Groundwater Review Summary Form

Application # G- 18876

PUBLIC INTEREST REVIEW FOR GROUNDWATER APPLICATIONS

A. GENERAL INFORMATION: Applicant's Name: Marina Sharabarin County: Clackamas

Water-Level Trends in Nearby Wells

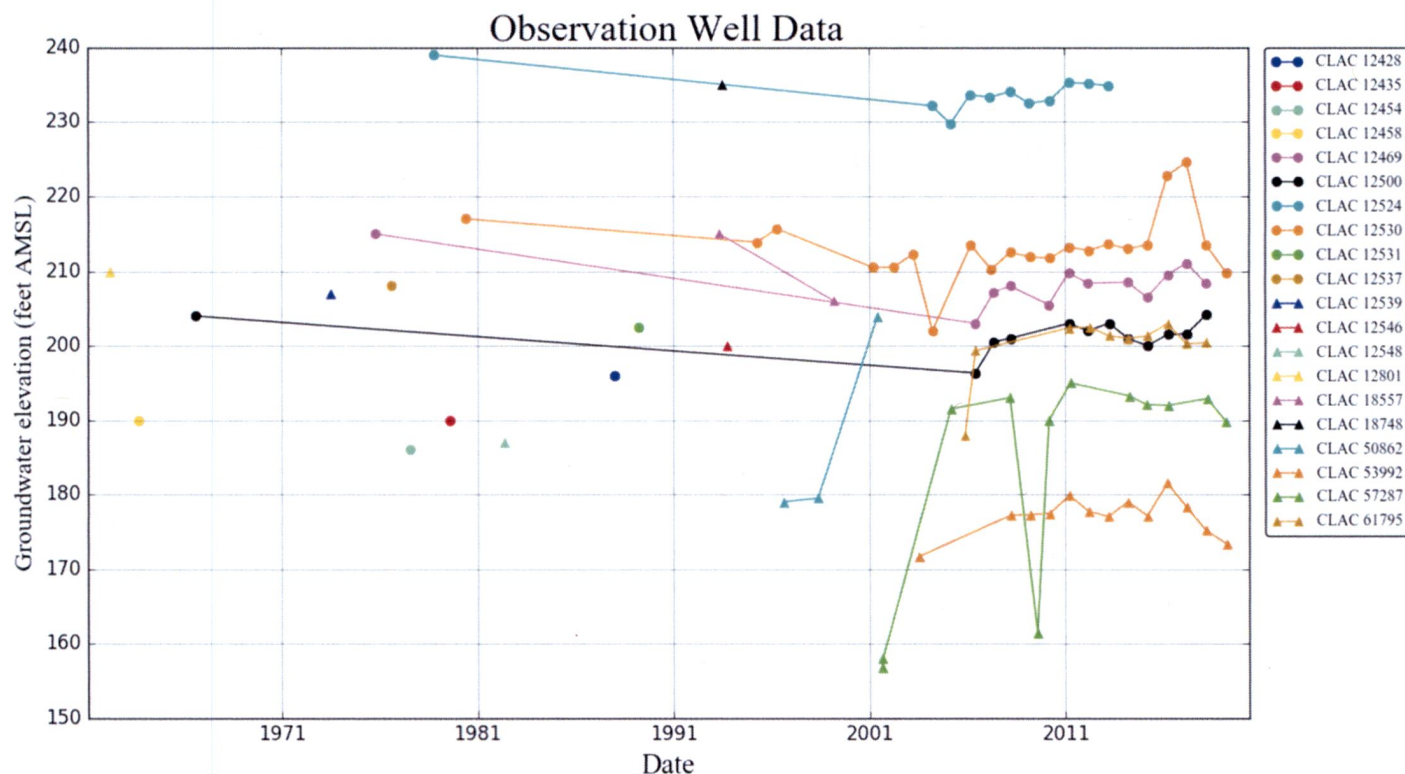
Since most of the productive water-bearing zones in the aquifer system are confined, pumping at the proposed wells is expected to produce a shallow but widespread cone of depression. Impacts on nearby wells are not expected to be injurious because reported drawdowns on well logs for most wells are relatively small relative to the total water column available in the aquifer. Also, progressive confinement with depth should buffer some of the impacts to shallow wells. Therefore, groundwater for the proposed use will likely be available in the amounts requested without injury to prior rights. However, predictive uncertainties and the lack of any seasonal water-level trends in the area indicate that it would be prudent to require conditions to limit hydraulic interference and to monitor and report groundwater levels and water use.

Well Statistics

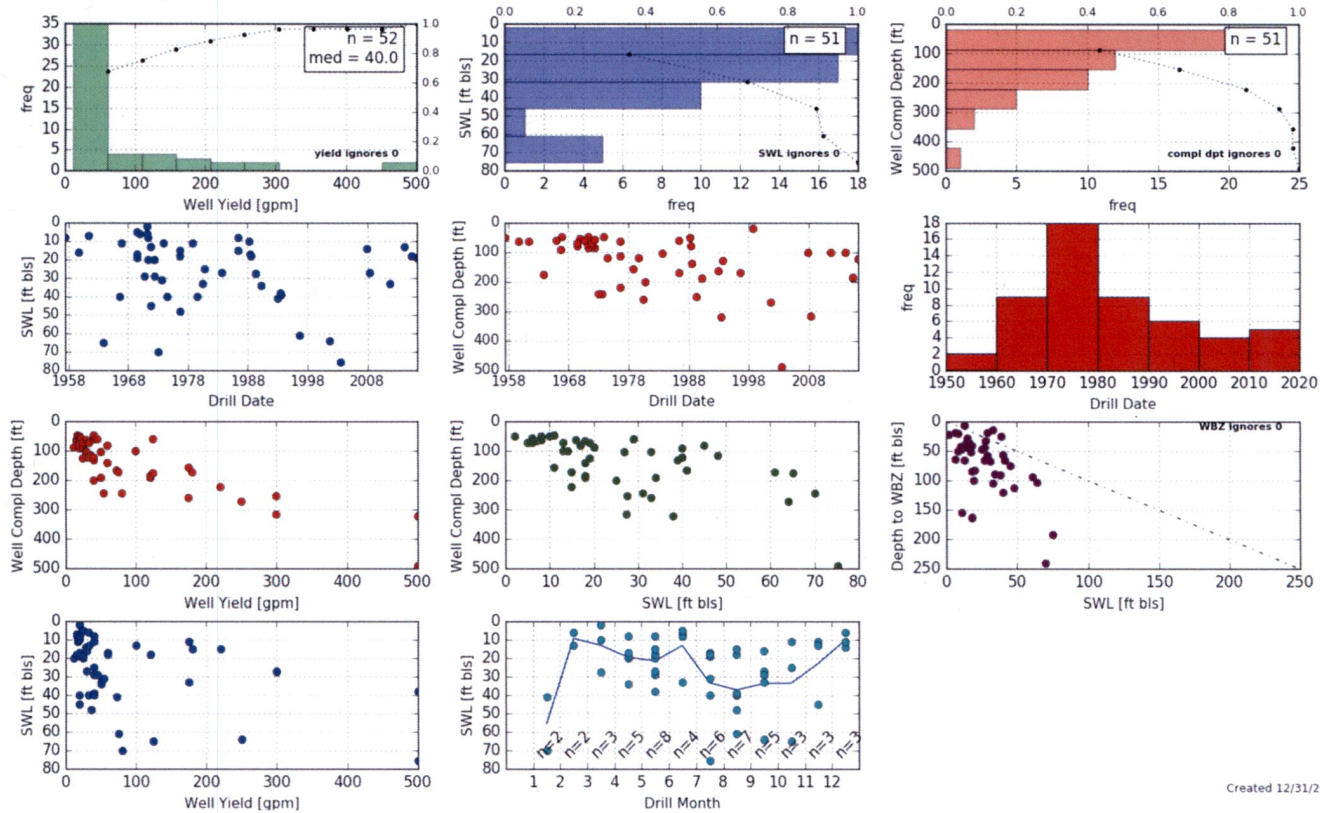
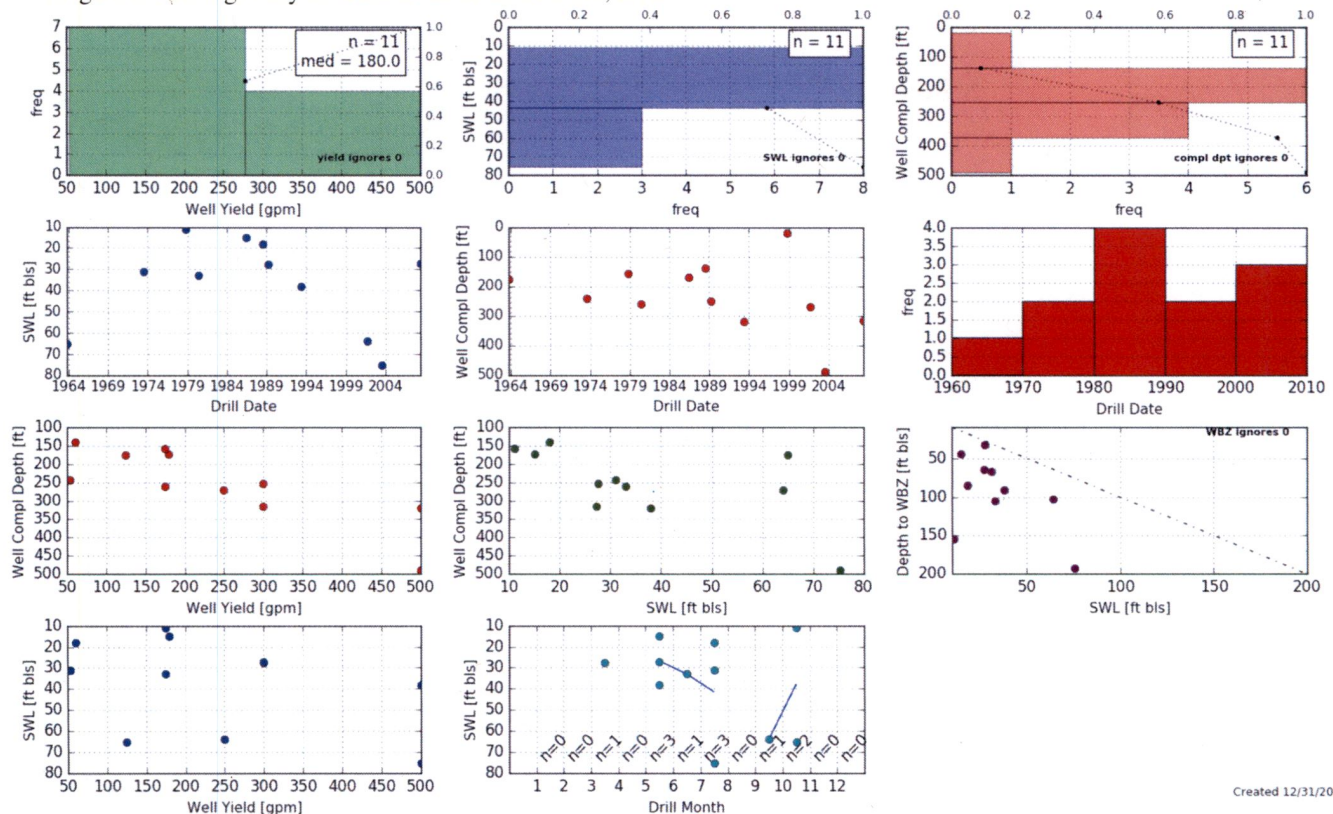
Well density is moderately low in the area. The OWRD well log database shows about 60 well logs of record in adjacent sections 25 and 26 of T4S, R1E. The median reported well yield is 40 gpm but yields range from 12-500 gpm. In contrast, well reports for 11 irrigation wells (most with 10-inch or greater casing diameters) show a median well yield of 180 gpm and

a range from 54-500 gpm. Well logs also indicate a general increase in yield with depth. Groundwater levels in nearby wells show relatively stable trends over time. These facts indicate that the applicant is reasonably likely to drill a new well that is capable of the proposed yield of 117 gpm and that groundwater for the proposed use will likely be available within the capacity of the resource.
